SG - building construction - General Assembly
and north parking garage - 1/82 - FTWS Inc

UNITED NATIONS CONTRACT

RE: CONTRACT HQ 1/82 - GENERAL ASSEMBLY AND NORTH PARKING SPACE
ESTIMATE FOR CHANGE NO. 190
"Acoustical Revisions of Studios 3 to 9
Inclusive and Testing Room 1B-58 -
1st basement-G.A."

2	HGP-101-1	18 Oct '51	Developed Elevations of E & W Walls & Schedule of Brackets
2	101-3	26 Oct '51	Angle Wall Supports - Below Booths & Bent Plate Brackets from Booth to Checks

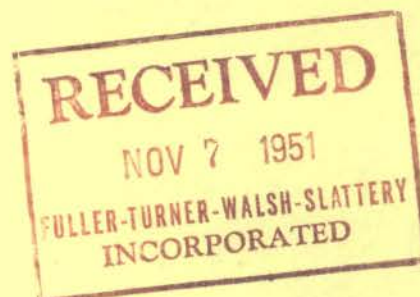
(APPROVED AS NOTED 7 Nov 1951 HEN RESUBMIT)

3 GA-1B-16 2 Oct '51 1st Smt. Duct Layout

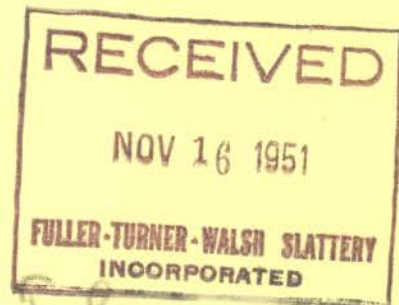
(APPROVED AS NOTED 8 Nov 1951 VR RESUBMIT)

"This drawing is approved, except as noted in yellow crayon."

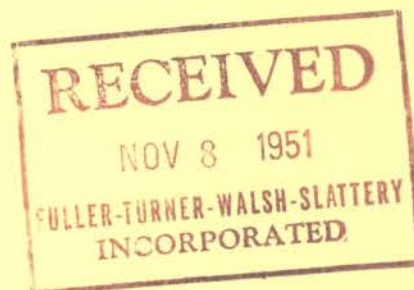
NOTE: STAIR 10 & 11 SHOULD BE OMITTED FROM THIS DRAWING, THEY WERE APPROVED
ON DWG. HGP-46-4 IN MARCH YL.
